# 2022/0092/HOU - Written Representations

To: Lincoln City Council Application Ref: 2022/0092/HOU

#### Proposal: Erection of single storey outbuilding to rear elevation

Location: 7 Western Avenue, Lincoln, Lincolnshire, LN6 7SR

Photo 3

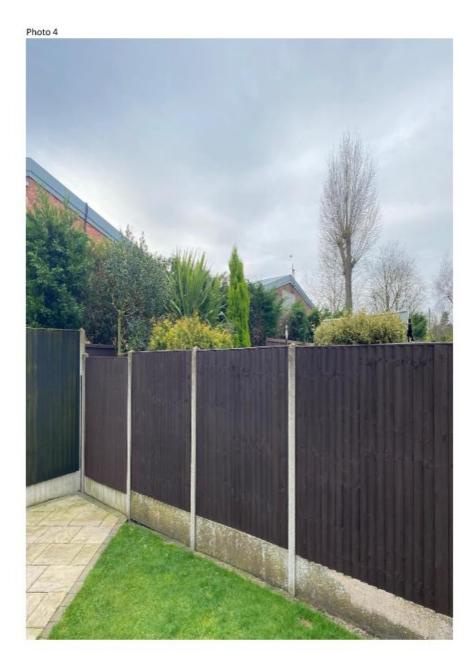
- This is particularly the case for our patio in the southern half of our garden (as demonstrated in photograph 3 attached) and worsened given the applicant's land is already higher in level than our garden, as stated above.

Photo 7

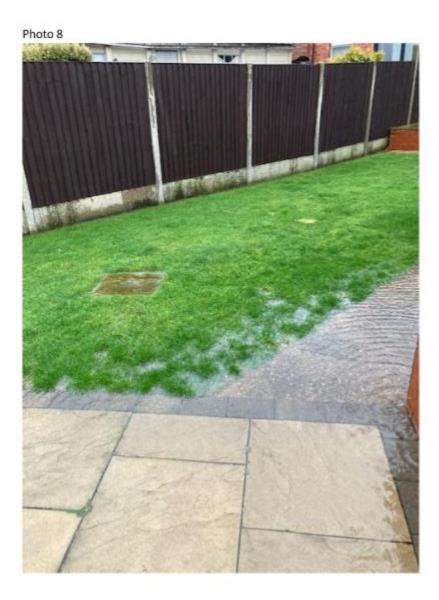
- The properties at the eastern end on the southern side of Western Avenue often floods during rainfall, due to the land levels being lower at this end of the Western Avenue and poor drainage in the area. See photographs 7-11 showing the flooding from recent rainfall in our garden.

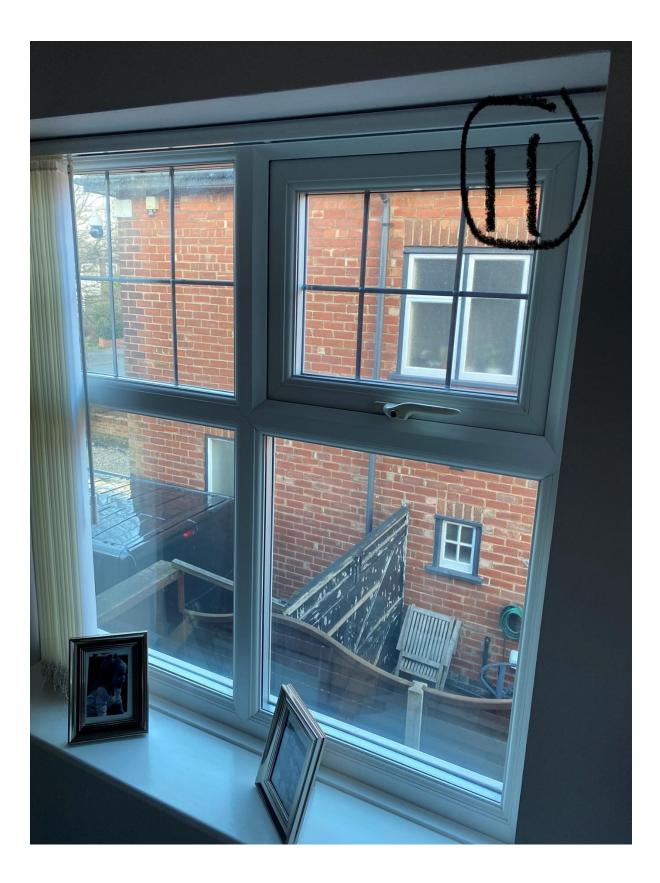
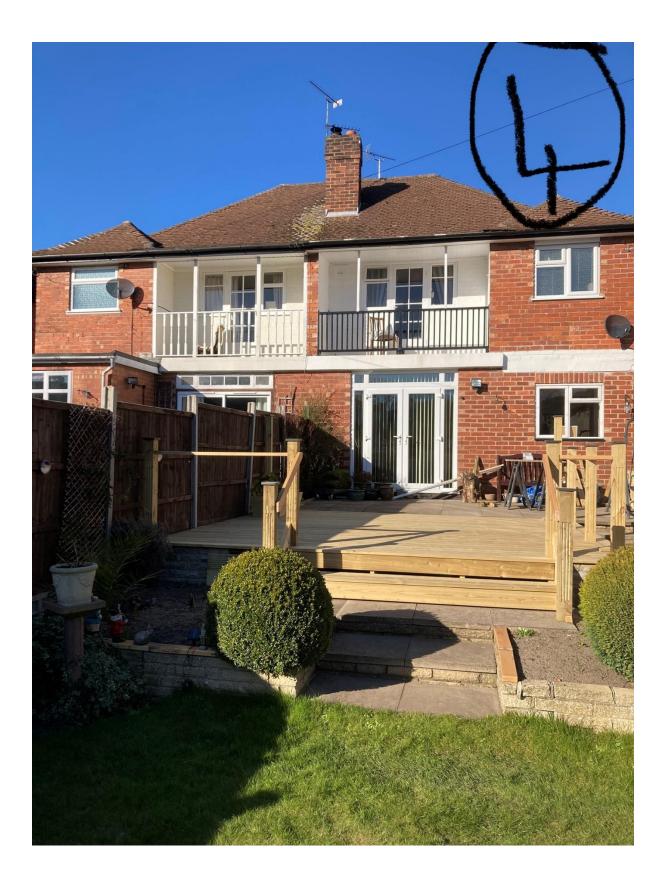
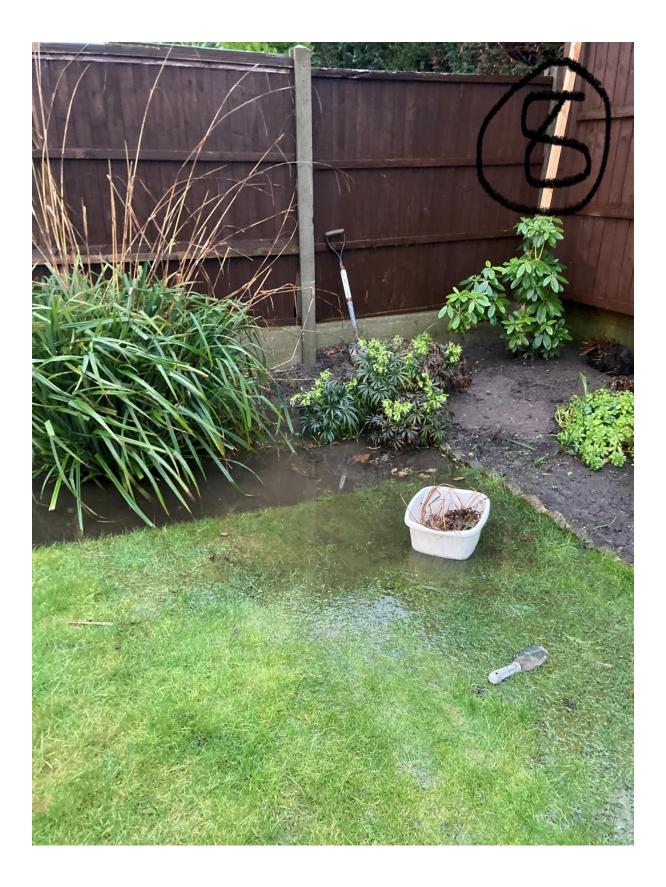
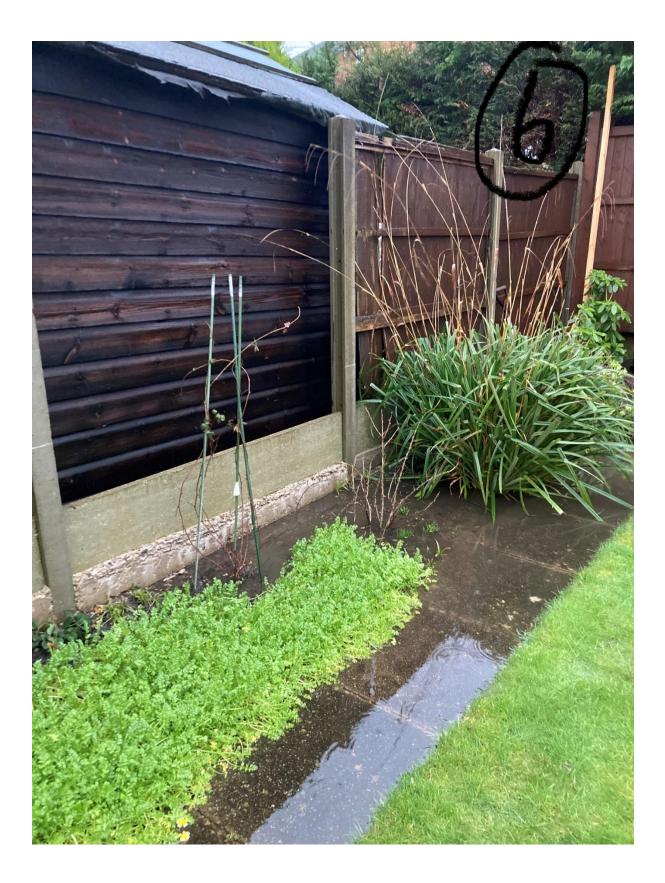
the garden's boundary. These trees are managed by the Bowl's Club to the rear and when these are trimmed it is likely to be on a level with the height of the proposed building. I would also like to note here that this is from ground level in my garden, the applicant's garden sits higher than mine so the height would be taller than the top of the wood I am holding.

Photo 3 – Can I draw your attention again to the piece of wood I am holding, this time demonstrating where the building proposed would come forward to. This picture also offers example to the height of the proposed building being more so than that of anything currently standing.

Photo 4 – This Image shows the view from the middle of my grassed area in the garden. As you can see there is clear view to my lounge/dining area and also into the master bedroom and balcony – also that of number 11 Western Avenue.

Photo 5 – This is an image taken from my balcony – this goes to demonstrate how the view of the area would be affected by the proposed building and how unfitting it is with the current surroundings.

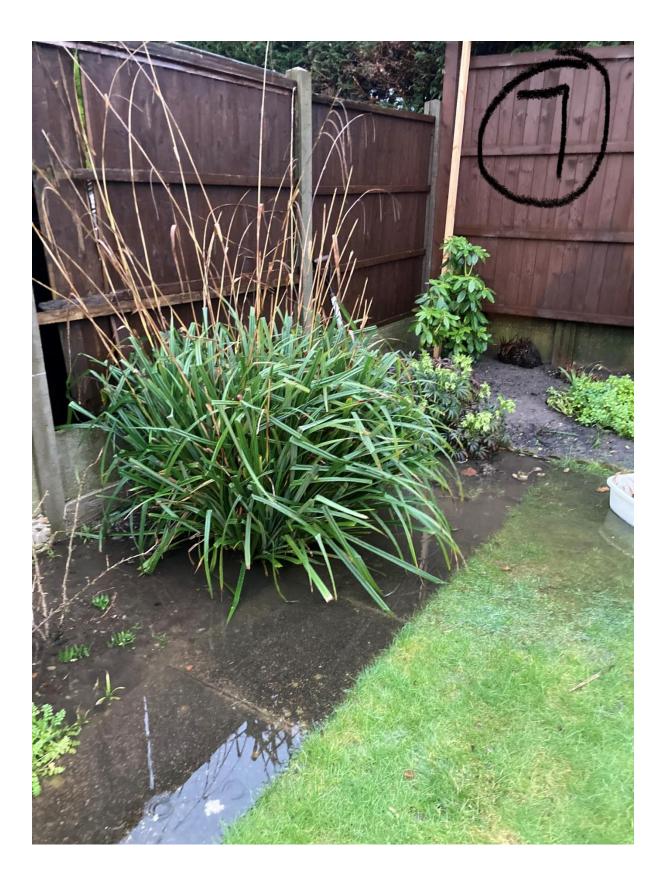
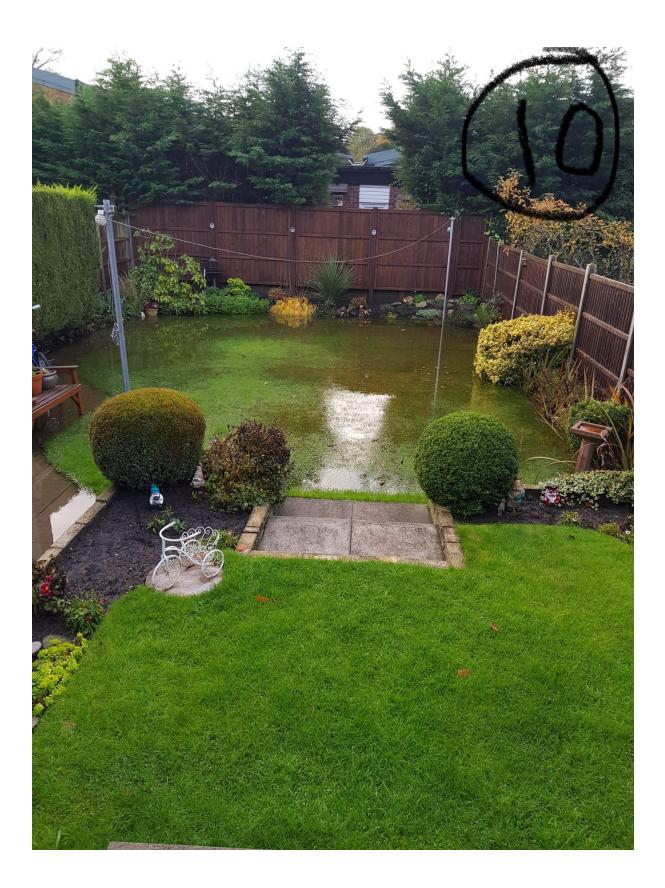
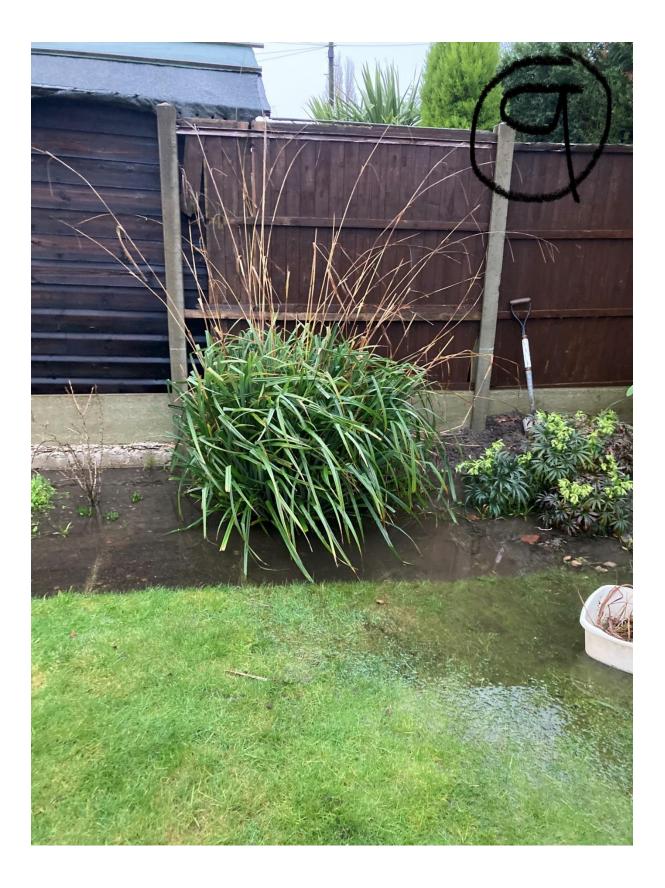
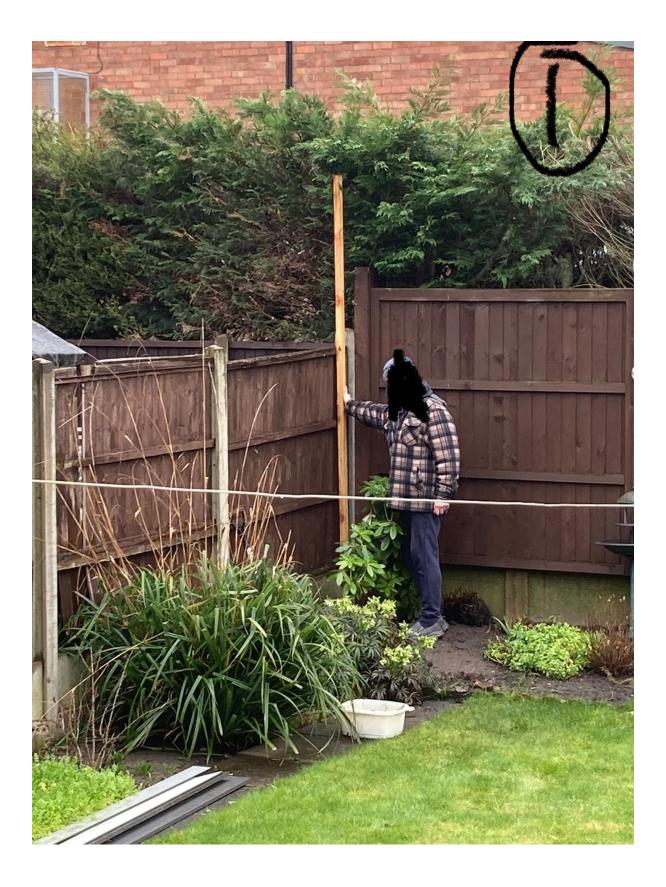
Photos 6,7,8 &9 – These images demonstrate the flooding and drainage issues. These images were taken recently on 20/02/2022 after minimal rainfall. These images are on my side of the fence between myself and the applicant's address.

Photo 10 – This is an older photo but one I happened upon in my photo gallery that demonstrates the flooding effect – as you can see the grassed area is swamped.
